January 12, 2024

Subject: Approval to Manage Contaminated Soil under Wis. Admin. Code § NR 718.12 on Site  
128<sup>th</sup> PFAS Investigation, 1919 E. Grange Avenue, Milwaukee, WI  
DNR BRRTS Activity #: 02-41-582725, FID #: 241496970

- Excavation/Cap Map
- Cap Maintenance Plan

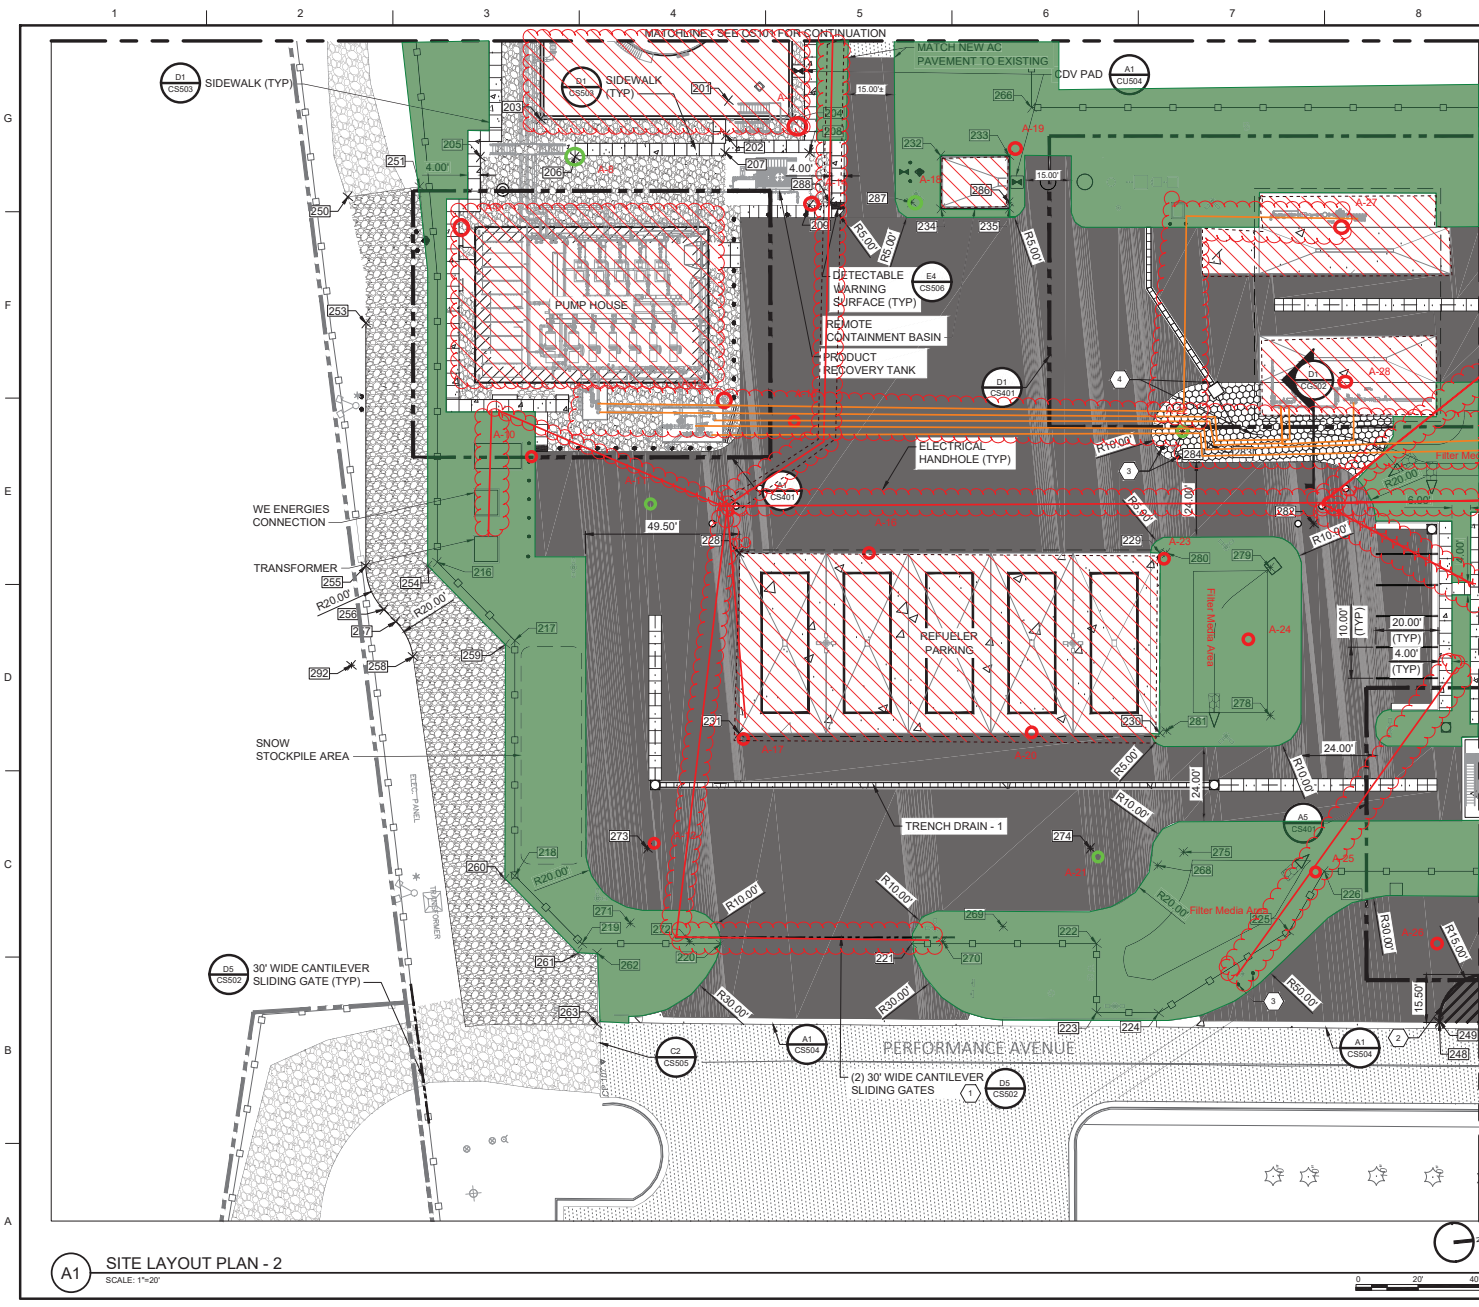
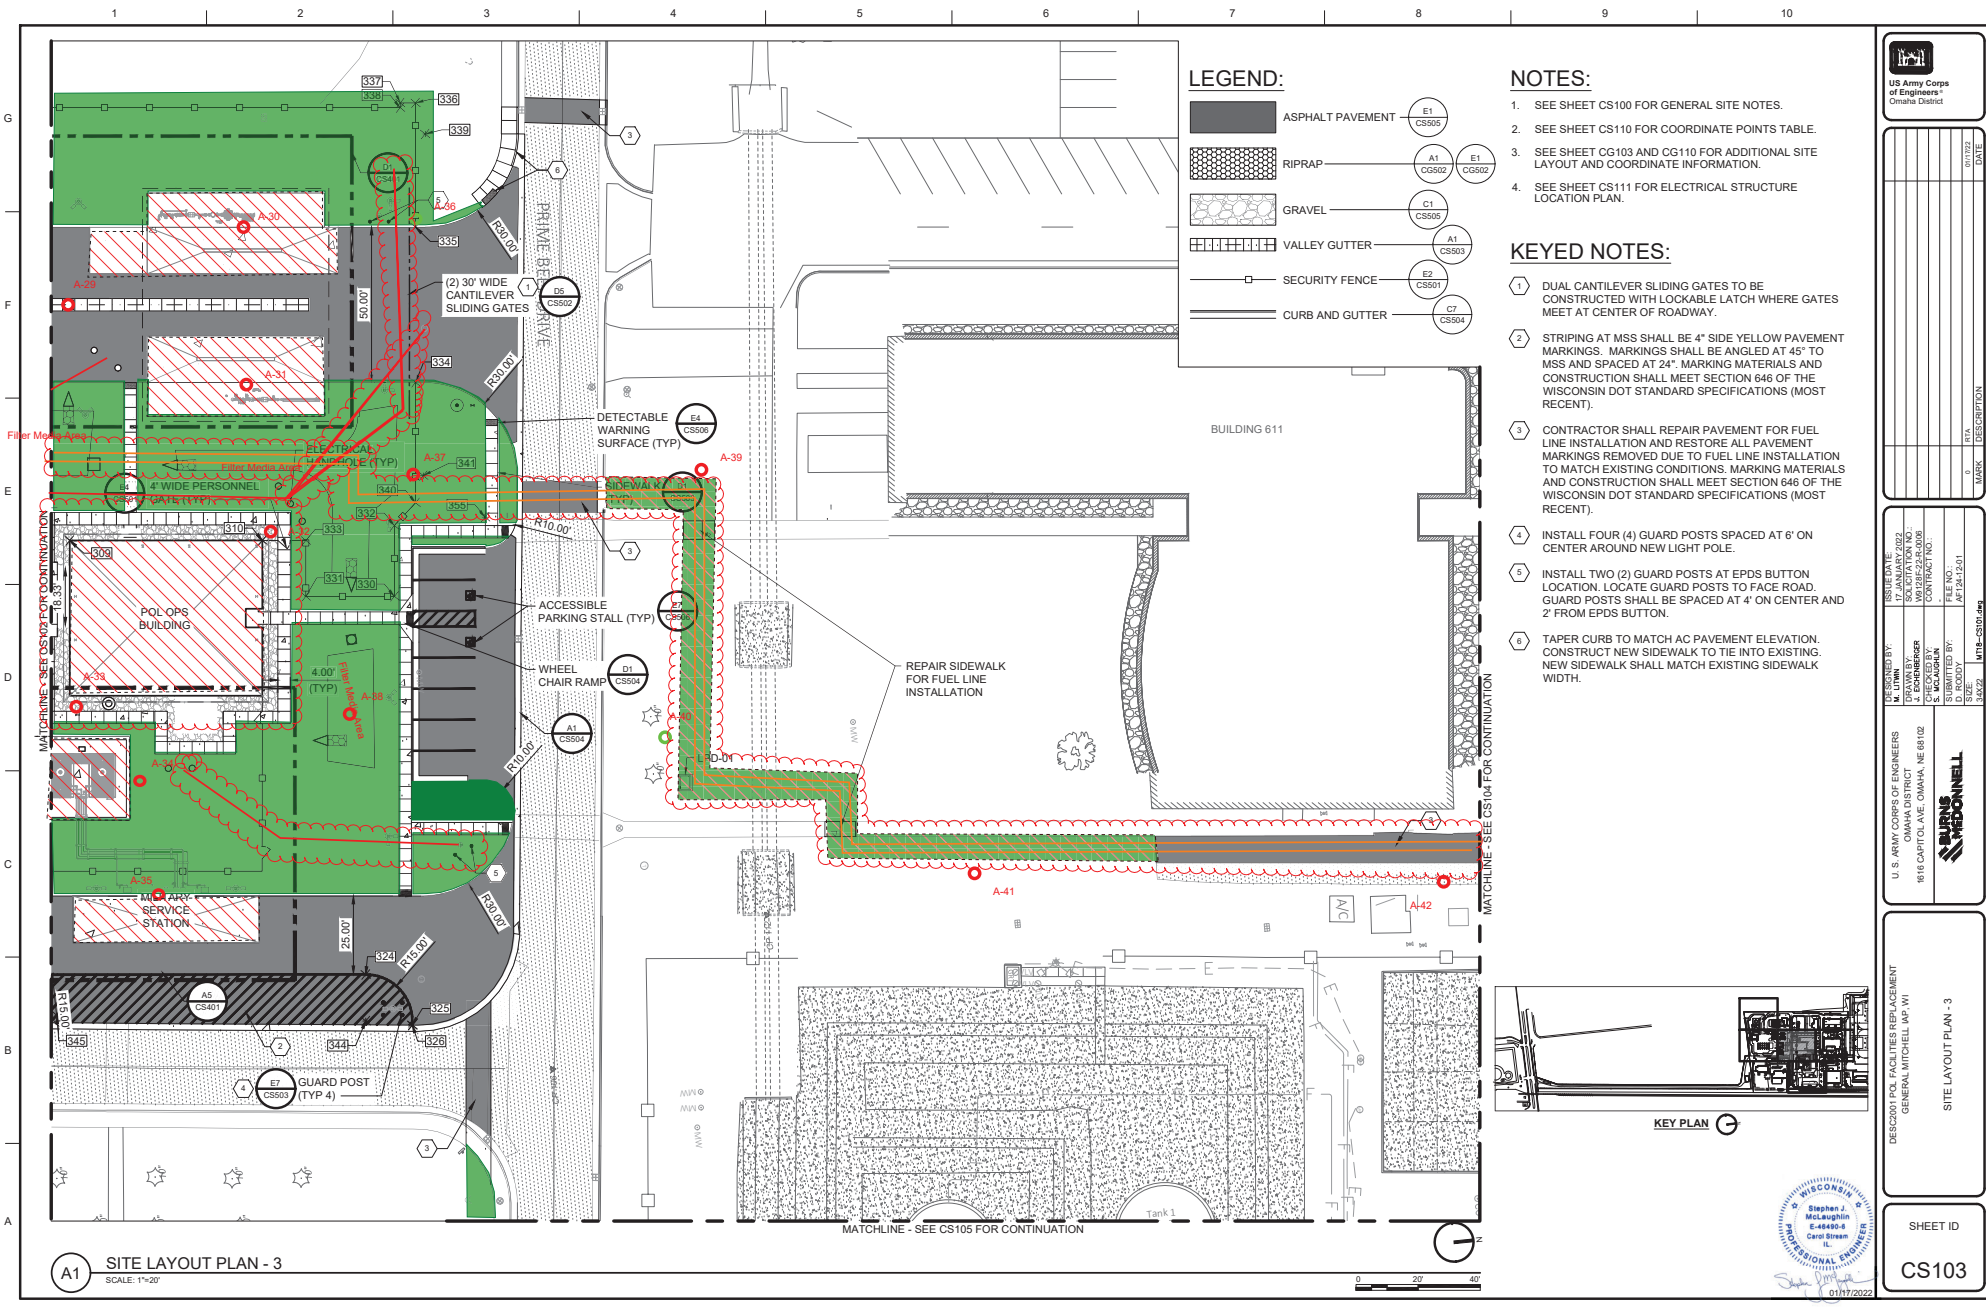
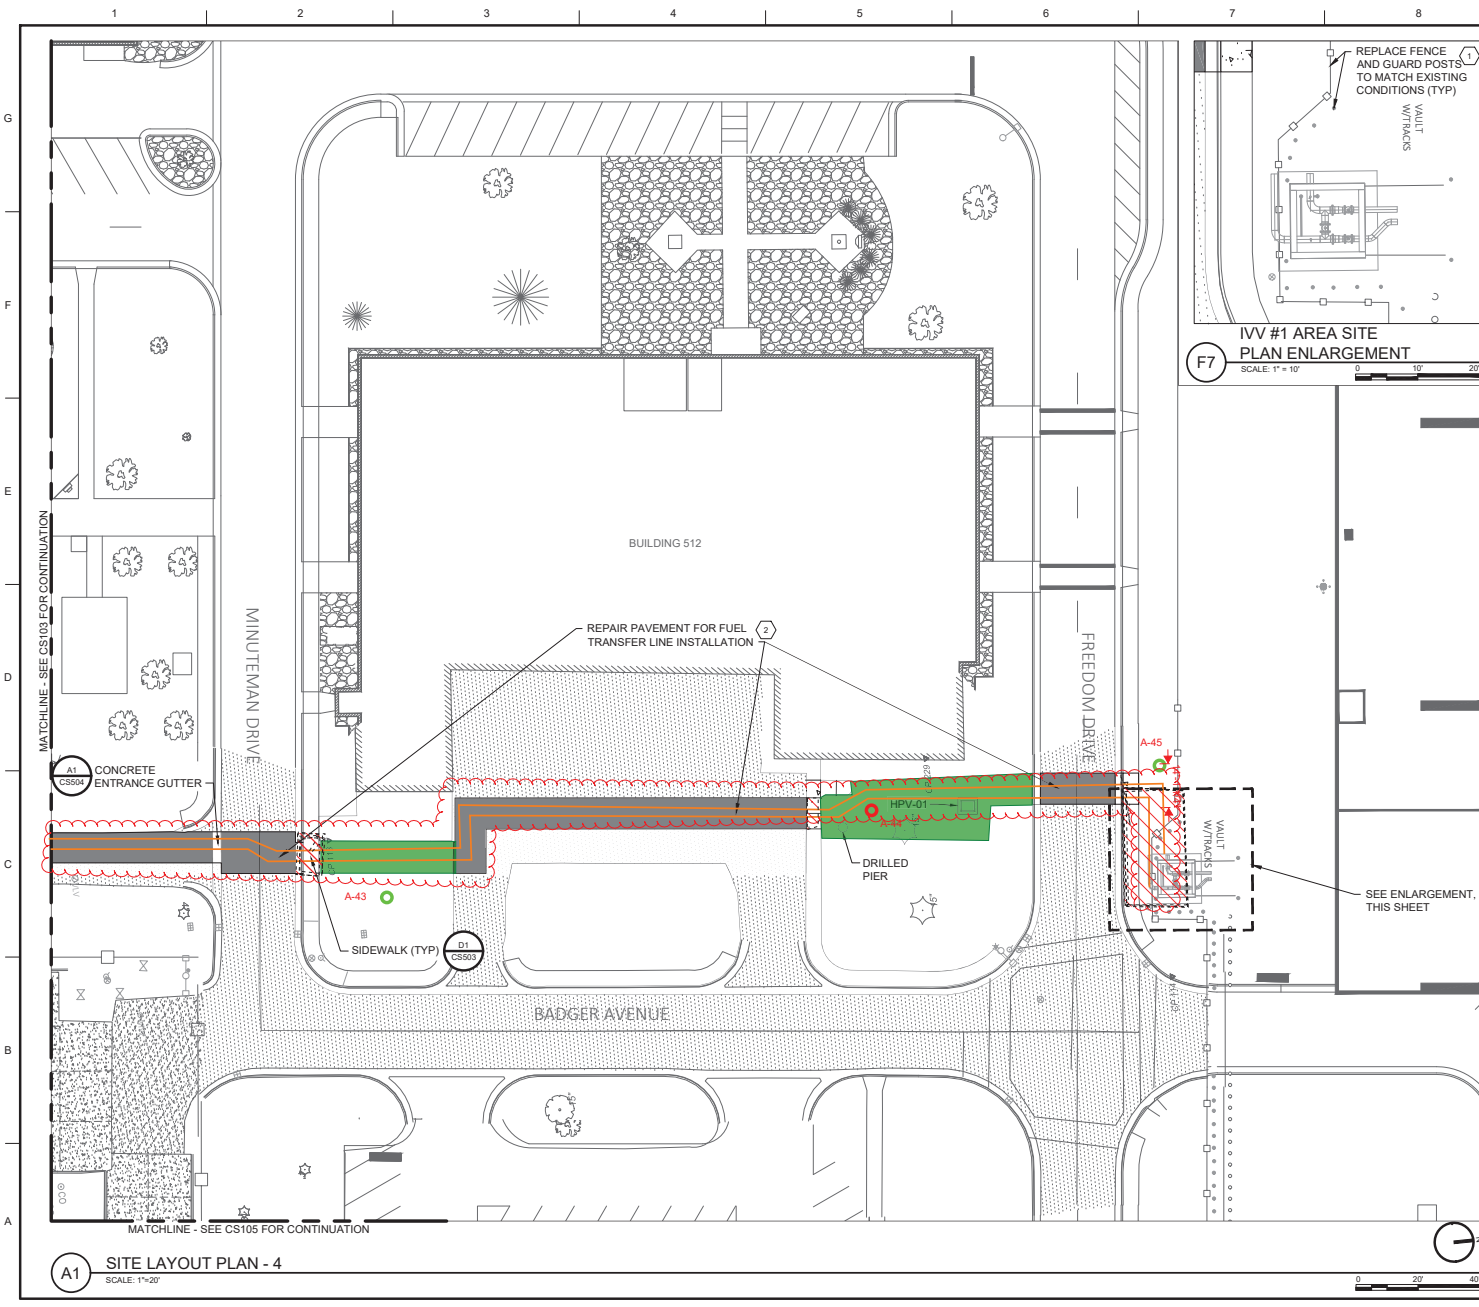
Managing contaminated soil in areas of the site identified on the excavation/cap map (attached) of the soil management approval request will meet the locational criteria listed under Wis. Admin. Code § NR 718.12 (1) (c), exception for the following:

- Within 3 feet of the high groundwater level.

In consideration of site conditions and the nature of backfilling the excavations with the same material removed from them, in the same locations and order, the DNR grants an exemption to the location criteria of Wis. Admin. Code § 718.12 (1) (c) 5 and will allow placement of contaminated soil material within 3 feet of the high groundwater level.
